METZGER PARK BASEBALL & SOFTBALL FIELDS

ADDENDUM #2

September 14, 2023

THRASHER PROJECT #101-T30-11111

UNDER DRAIN & PLAYERS BENCH DETAIL

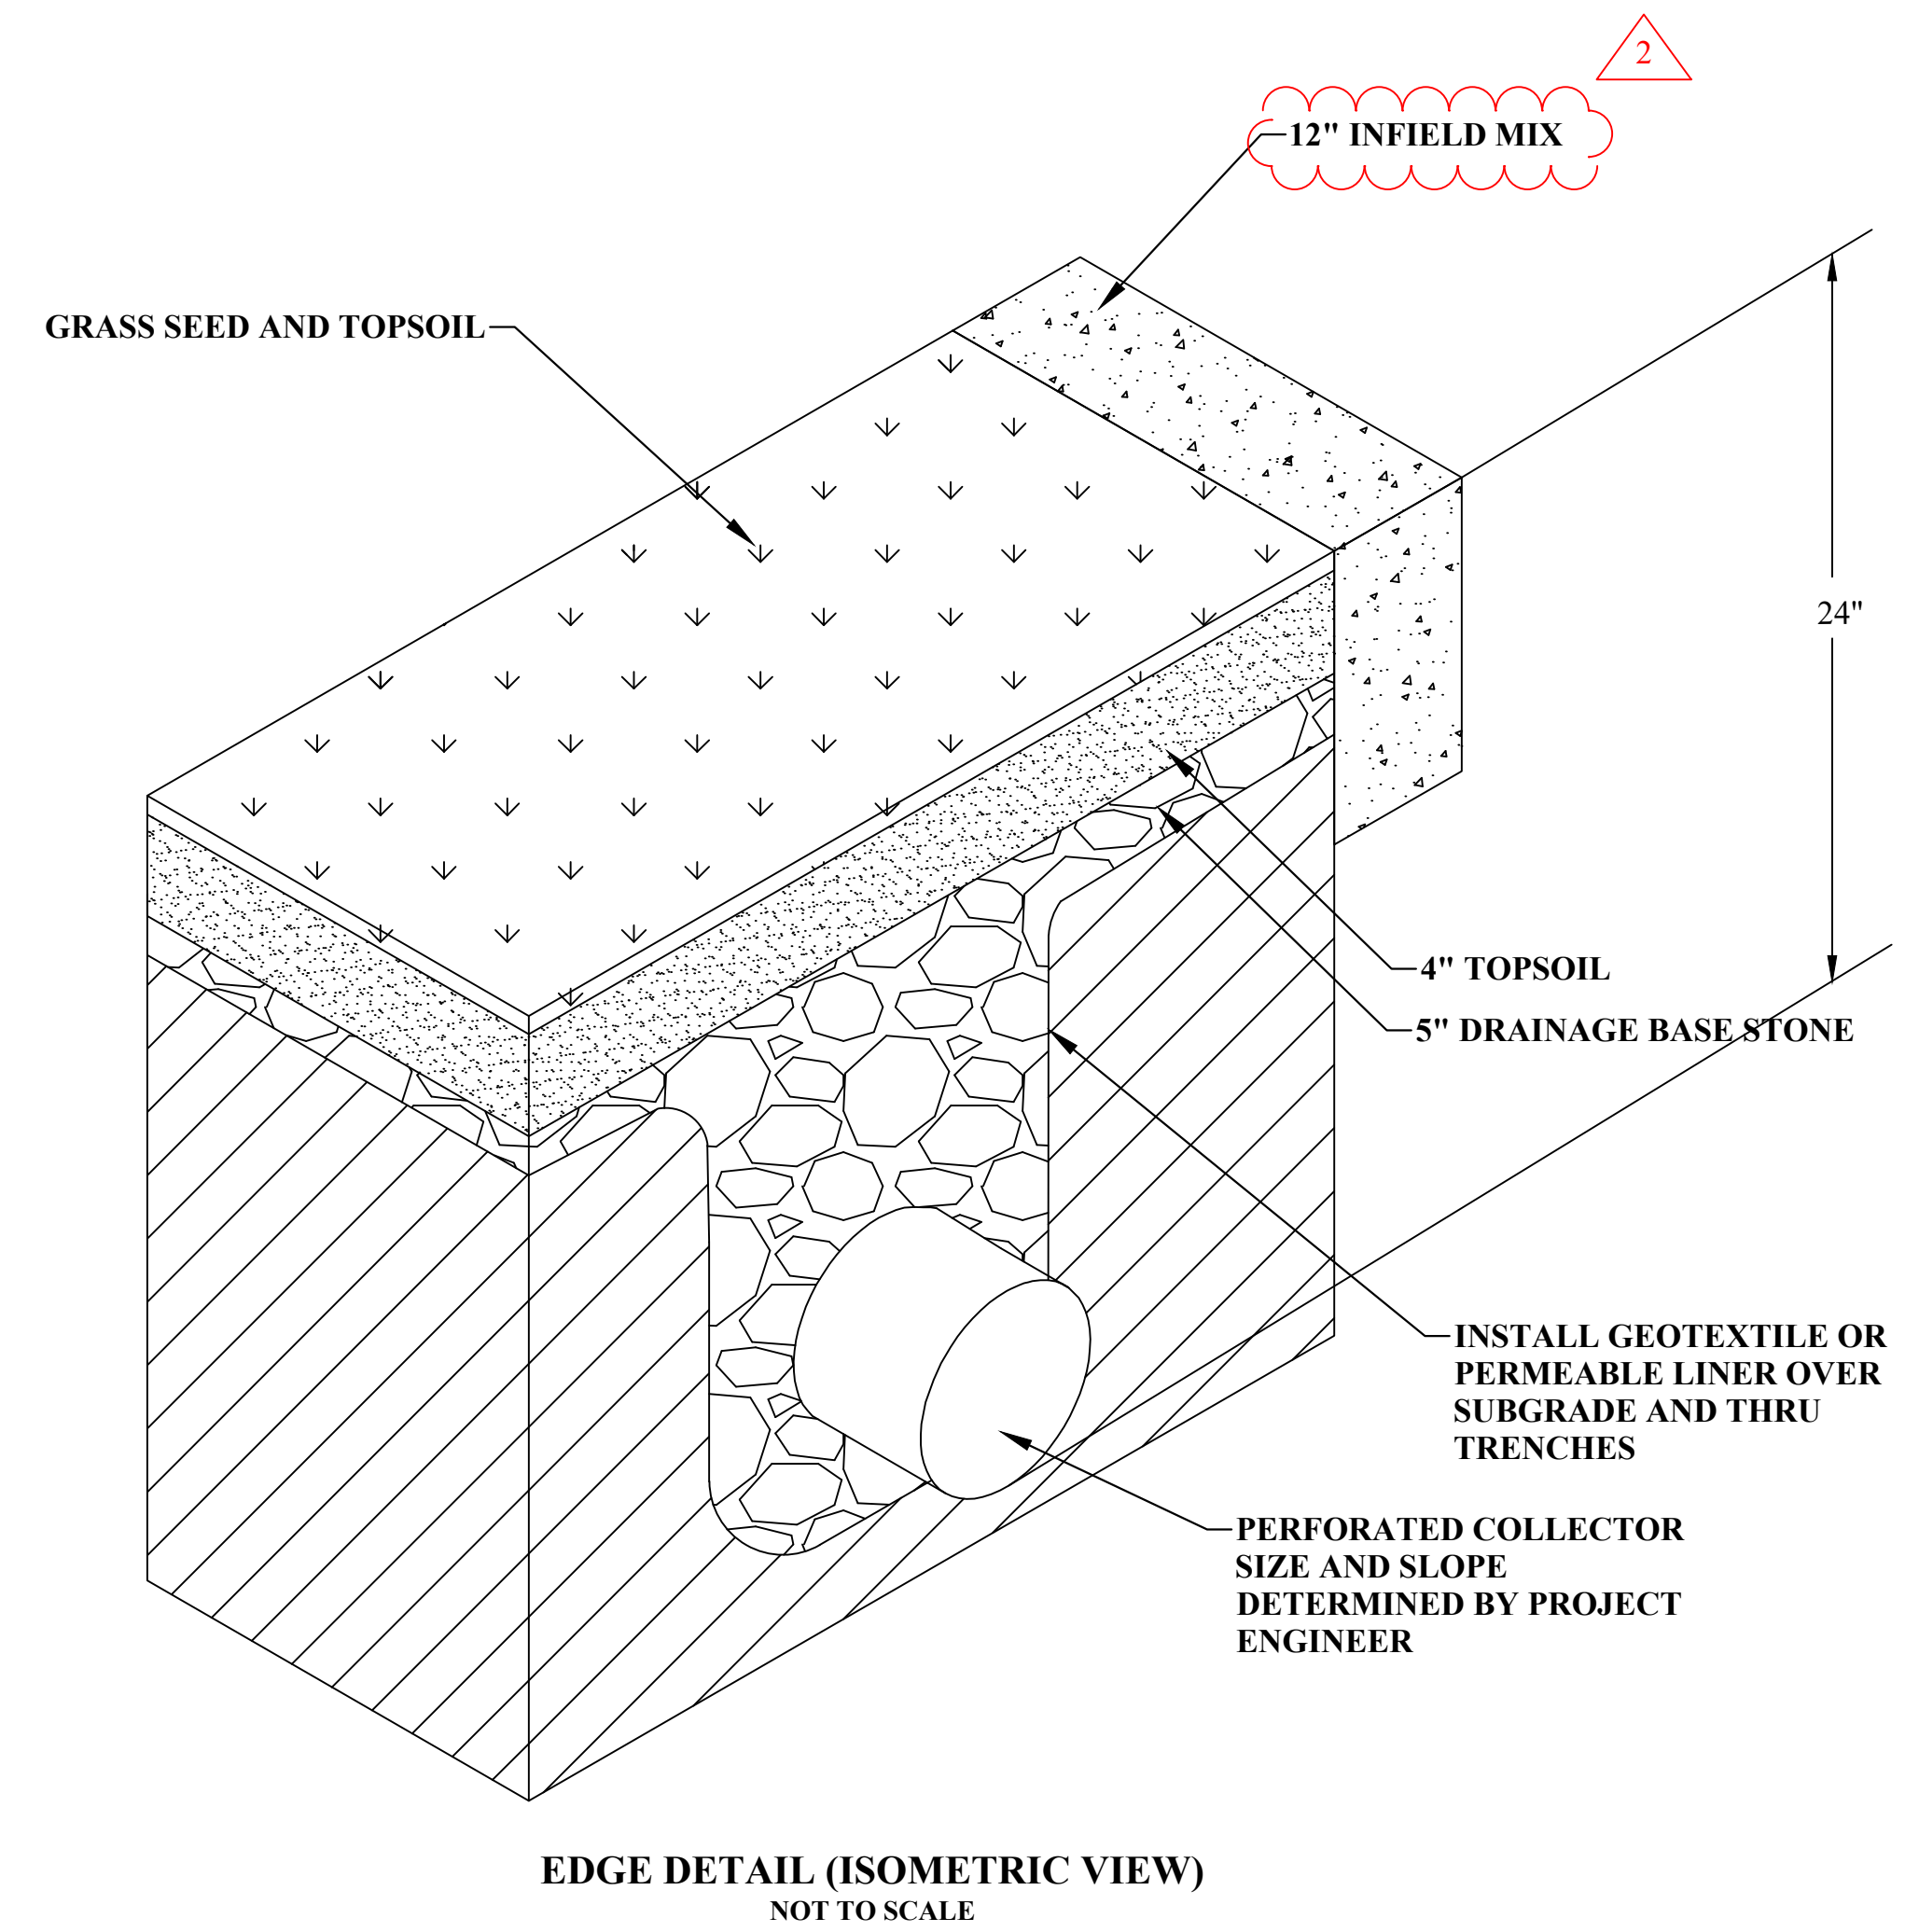
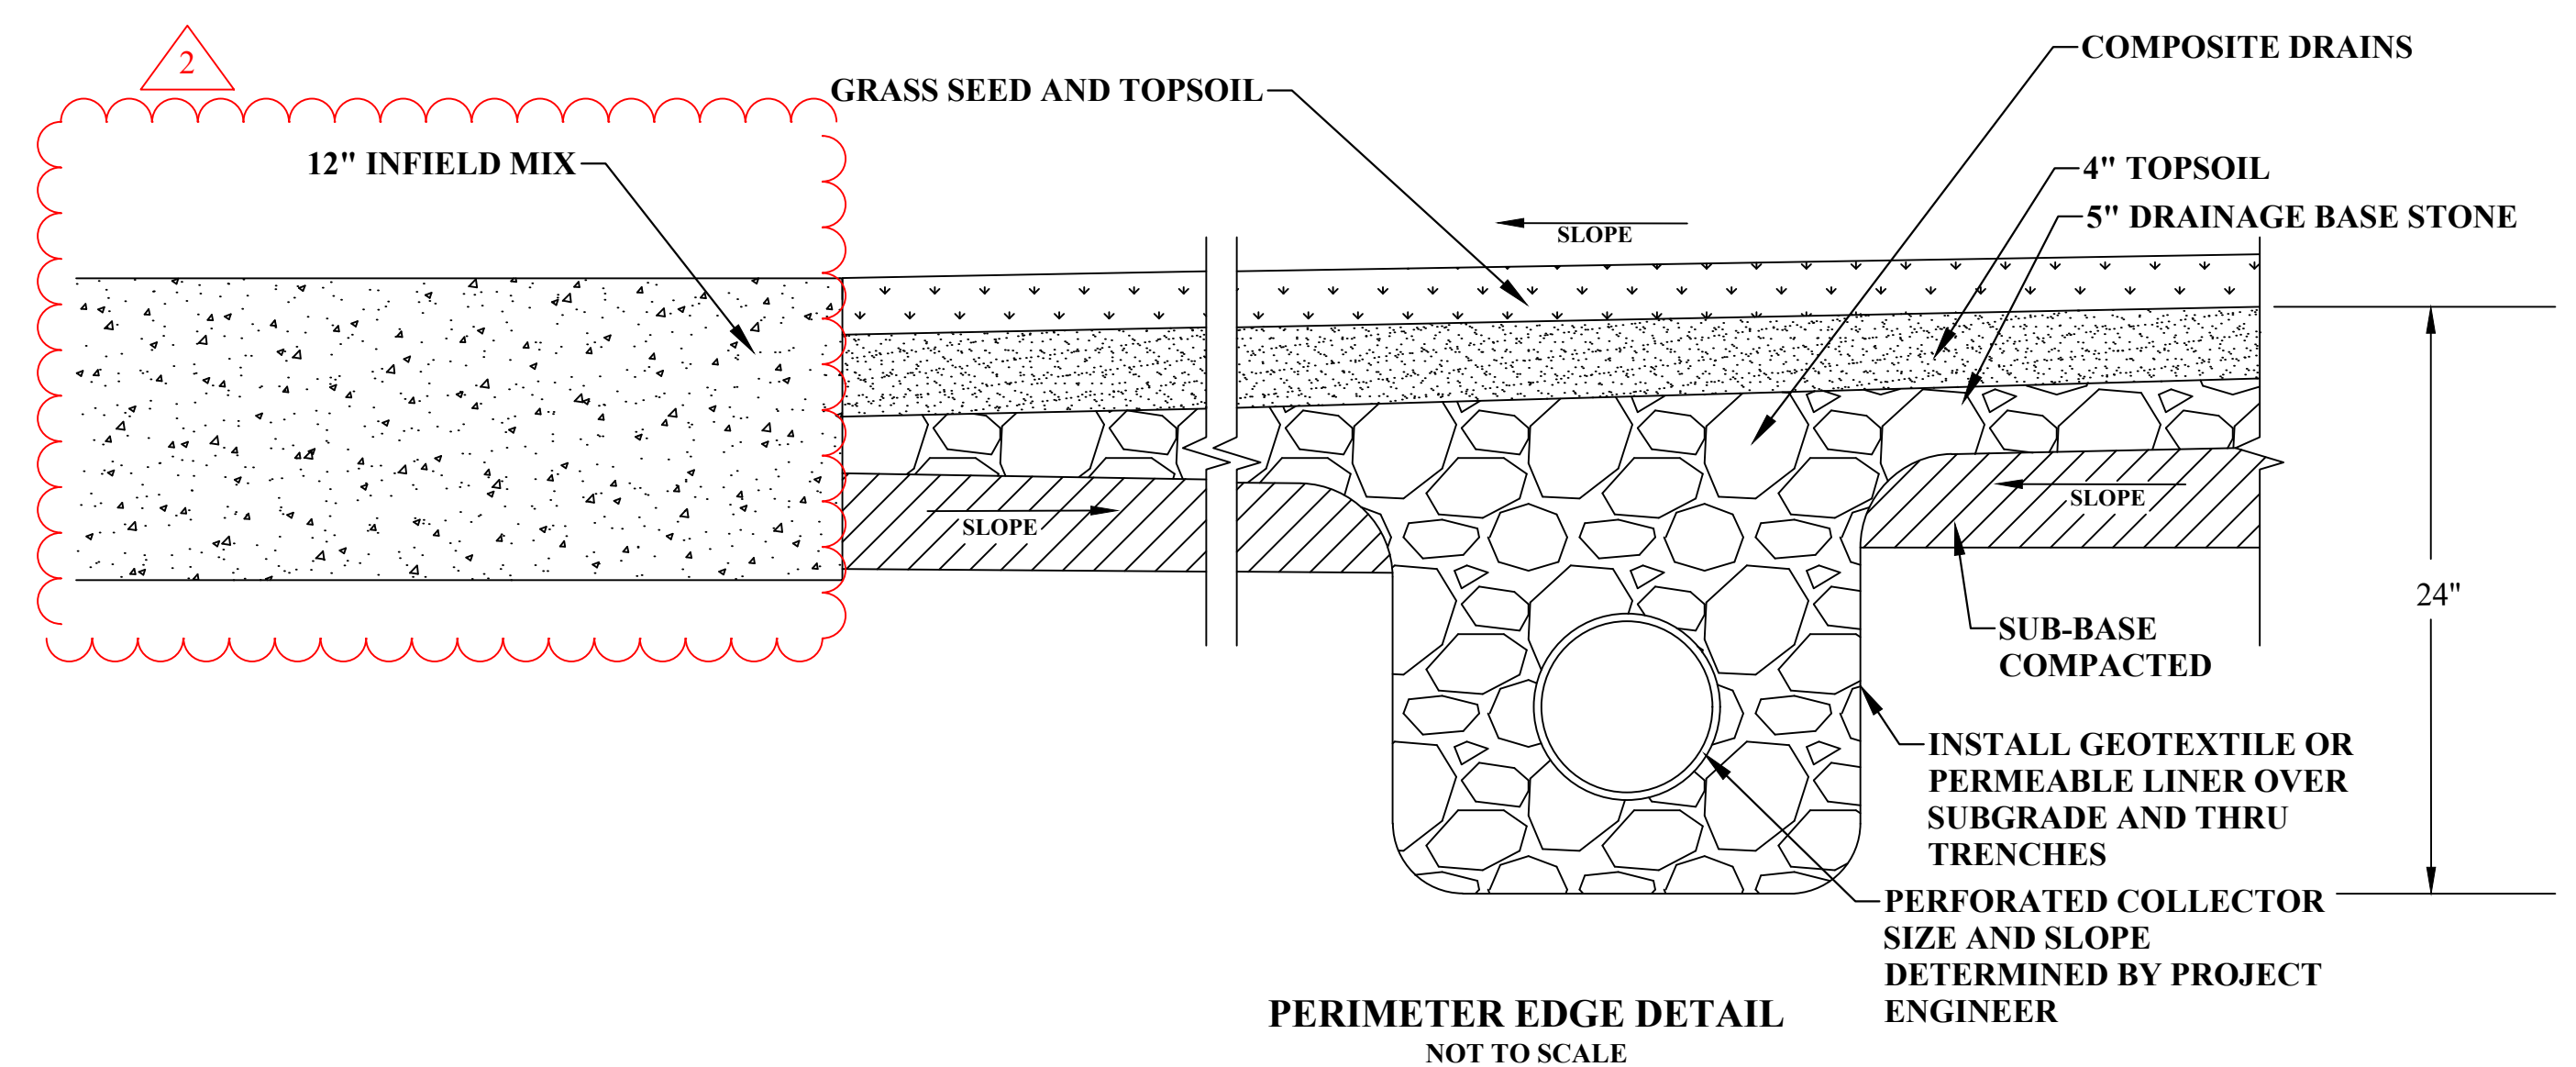
NO.	BY	DATE	DESCRIPTION
01	FMK	09/14/2023	ADDENDUM - 2 - REVISED THE FIELD DRAINAGE NOTES NO 2 & EDGE DETAIL

2. NAILER WILL BE INSTALLED AROUND THE PERIMETER TO PROVIDE A SECURE EDGE TO STOP FIELD MIX MIGRATION. IN ALL CASES THE NAILER AND STONE ARE AT THE SAME ELEVATION.
